## SAFETY RECALL G-09501

### INTERIM NOTICE

This notice is being sent to you in accordance with the requirements of the National Traffic and Motor Vehicle Safety Act. IC Bus has decided that a defect which relates to motor vehicle safety exists in certain BE, CE/ IC/ CS, and FE model commercial and school buses built 2/2/00 thru 6/2/08 with a stepwell heater feature code 0048PMS or 0548001 (Figure 1), and/or rear wall mounted 75,000 BTU heater feature code 0048TAR or 0048PSX (Figure 2).

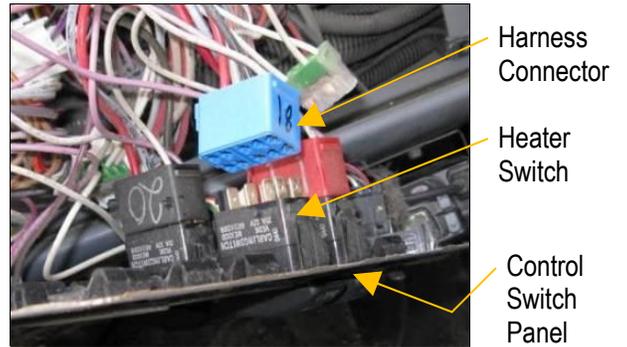
4. Depress the locking tab and remove the harness connector from stepwell / wall mount heater blower motor switch.

5. Depin the 12 gauge blue wire in cavity 3 of the harness connector using a spade tool to depress the terminal tab while simultaneously pulling the wire.

6. Tape the depinned blue wire out of the way to prevent damage to the terminal. This wire is not energized to power and will be reinstalled in the final repair.
